UNITED STATES
NUCLEAR REGULATORY COMMISSION
WASHINGTON, D. C. 20555

Subject: Requests for Additional Information in Fermi 2 Operating License Application

HUMAN FACTORS ENGINEERING
CONTROL ROOM DESIGN REVIEW/AUDIT REPORT
OF
ENRICO FERMI 2
DETROIT EDISON COMPANY

REQUESTS FOR ADDITIONAL INFORMATION IN THE SAFETY REVIEW

Figure 1

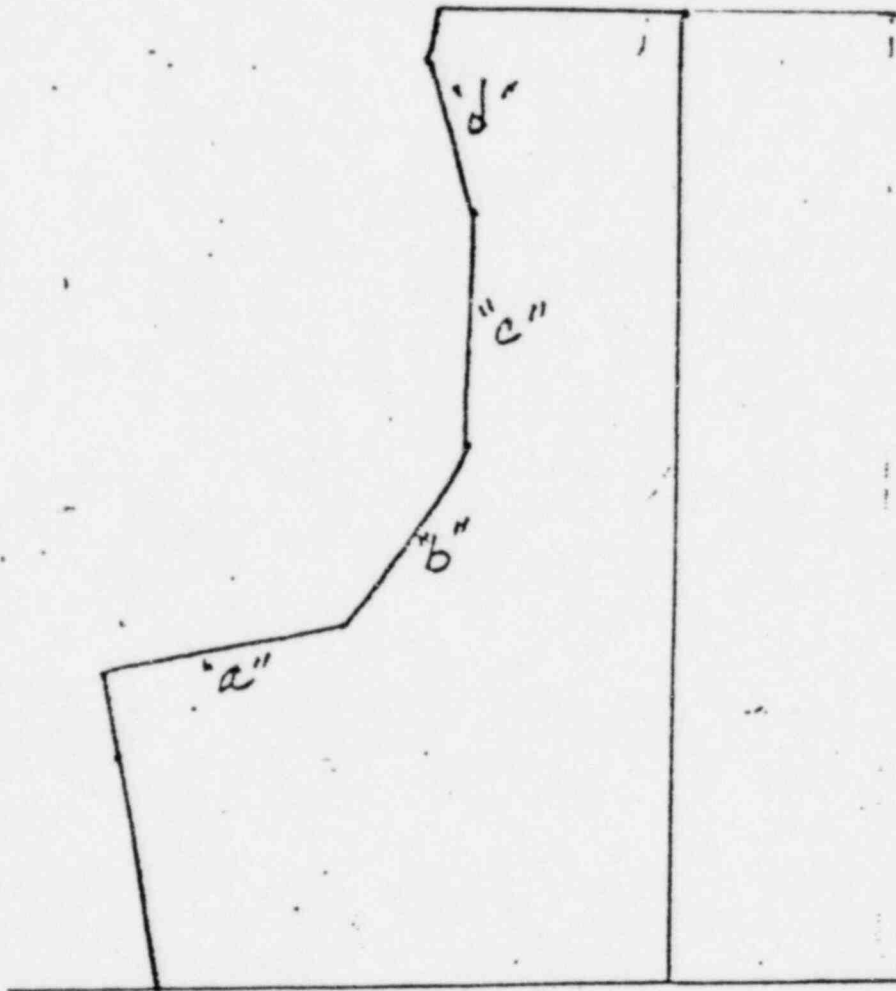
<u>PRIORITY RATING</u>	<u>FINDING</u>	
1	1	The HVAC could not be evaluated because it was not completely installed.
3	2*	On Panel-805 the lighting on the "c" surfaces was lower than recommended levels whereas "a" and "b" surfaces were within an acceptable range. (See Fig. 1) (See Fig. 1)
3	3	Under some lighting conditions the contrast between indicator lights and background is low on Panel-805. (CMC switch on surface "b"; push button switch on the sloping surface "a".) (See Fig. 1)
1	4	There are inadequate normal and emergency lighting levels on Back Panels 812 and 813, with the existing temporary system.
1	5	There is no emergency lighting available at the remote shutdown panel.
3	6	It is difficult to read the CRTs on Panels 603, 804, and the operator console because of low contrast caused by reflections.
3	7	There are shadows on the labels under the recorders on Panels 601, 603, 804, 805, which make them difficult to read.

1	8	The remote shutdown panel is not provided with communication with the control room or elsewhere.
1	9	The loudness of the paging system interferes with telephone conversation at the operator's console.
3	10	On the "c" panel of Panel-808, all recorders are too high for easy maintenance by a 5th percentile person. The most extreme case is SUPP, CHAM. BULK WATER TEMP. (See Fig. 1)
2	11	The magnetic tag-out buttons are subject to accidental movement and do not preclude inadvertent operation.
1	12	Administrative procedures for making permanent modifications to the control boards did not exist and could not be evaluated.
